**Consultation Response from Emma Mills
 KC Landscape**

Application No:	2021/94280
Proposed Development:	Erection of 67 dwellings with associated works
Location:	land at, Lady Ann Road, Soothill, Batley, WF17 0PY
Applicant/Agent:	Self Architects
Planning Officer	Nick Hirst
Date Responded:	16.12.21
Responding Officer:	EM
Responding Ref:	KK139

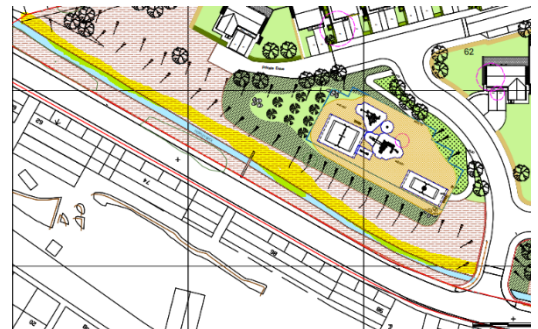
Policy LP32 requires development proposals to consider and seek to enhance the landscape character of the area.

Setting – this layout for 67 dwellings retains the large swathe of existing natural vegetation along the beck which is welcomed. Welcome retention of existing trees in the site, however opportunities to extend this green infrastructure through tree planting in adjacent gardens appears to have been missed.

Howley Beck runs through the proposed Public Open Space, clarification as to the delineation/measures to ensure that there is a clear definition of the water course in the residential amenity for safety of the users of the adjacent children’s play (bearing in mind some youngsters might not read signs).

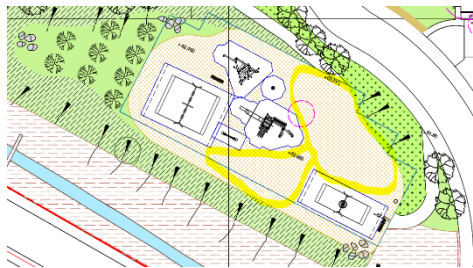
Play area layout – not sure this is the final design or indicative. A couple of queries about siting and location of proposed benches and equipment, this bench is in potentially blocking half of the access path.

Tree planting locations should be well thought out and trees positioned for their future growth and long term presence – also so as not to potentially damage the adjacent hard surfaces, root barriers also need to be shown.

Bark is shown as the safety surface – has DDA accessibility been considered? Bark is difficult to push wheelchairs and push chairs across, some more accessible areas would be beneficial to encouraging use by all abilities. There is a potential for this play area, with its play bark surface, to suffer in terms of useability due to potential poor drainage or becoming waterlogged in extreme wet weather being located adjacent to the Beck. Wear pads will be required under the swing, slide, see-saw, roundabout, etc.

Why is there such a large area of empty bark? Could this be a grassed informal kickabout area?

Good range of pieces of equipment included, compliments the offer in the vicinity, however, we would recommend this is metal play equipment in this location for durability (one of the pieces looks like a timber log stack climber with nets – is there a metal version?). Equipment appears congested in one area to the south – is there a reason for this?

No surfaced link path to the community growing area indicated – needs to be accessible as far a practicable for widest use by people of all abilities.

Slide ideally shouldn't be pointing S/SW due to heating up in the summer.

Natural playful elements such as boulders are welcomed, perhaps need connecting into the playable space and features a little? Used for linking other natural features or equipped play elements?
